DEVELOPMENT and PLANNING SERVICES COMMITTEE

April 03, 2018

SUBJECT: Development Variance Permit Application No. VP-470
Lot 2, Plan EPP61022, Sec. 19, Tp. 20, R.9, W6M, KDYD
2960 - 30 Street NE
Owners/Applicants: M. Pugh & S. Maslyk

SUBJECT: Development Permit Application No. DP-417 (24 Unit - Medium Density Residential)

TITLE:
ELEVATIONS

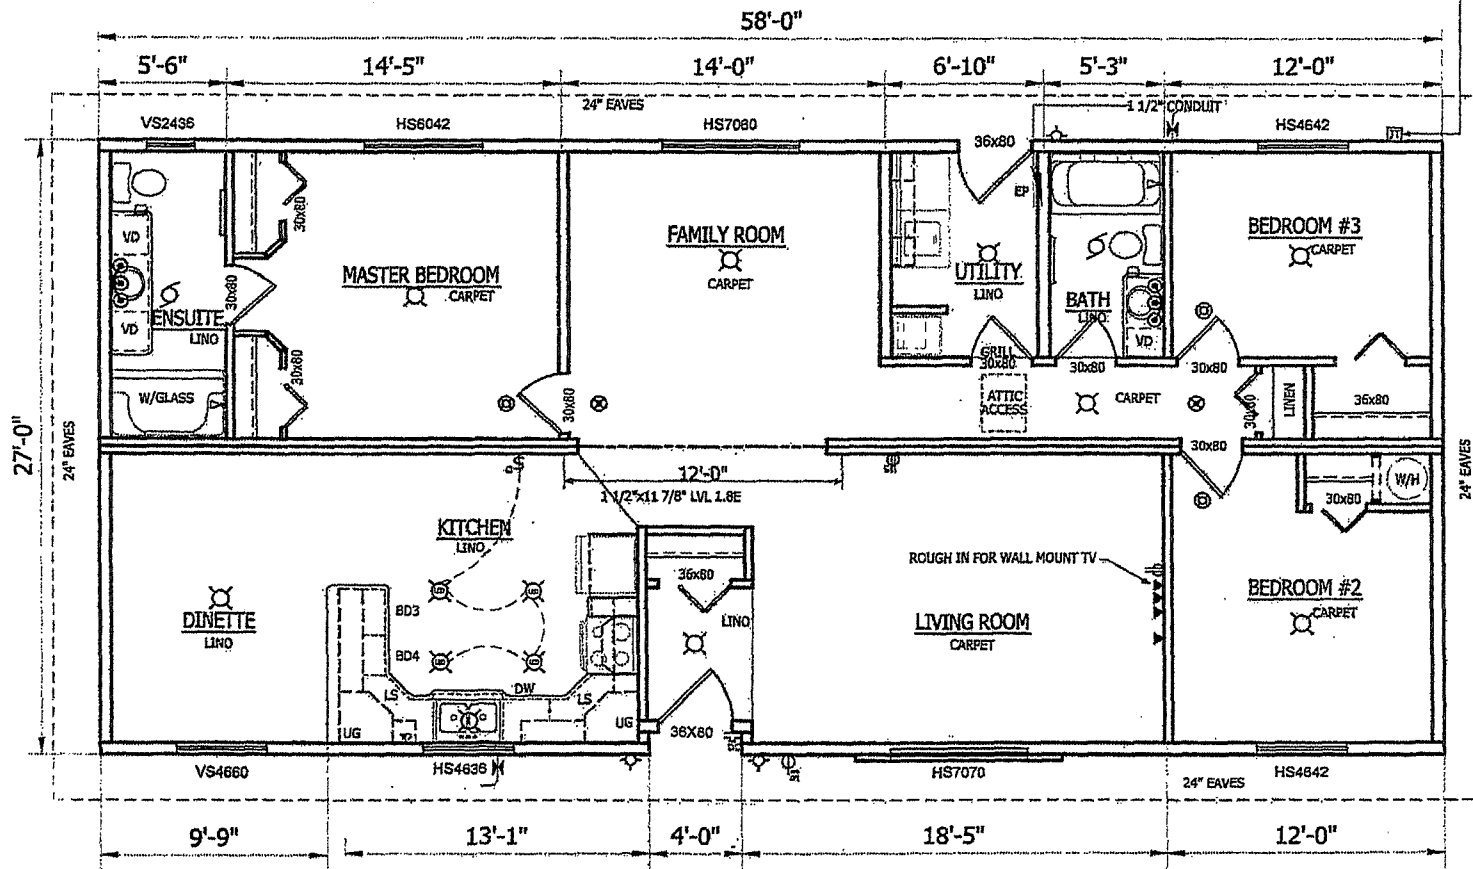
No concerns with variance however limiting distance requirements at 3 metres will only permit approximately 10% of the east wall of the residence to have glazed openings. (Preliminary calculations, based on the elevation drawings provided with the application, indicate the proposed modular dwelling will meet this requirement.)
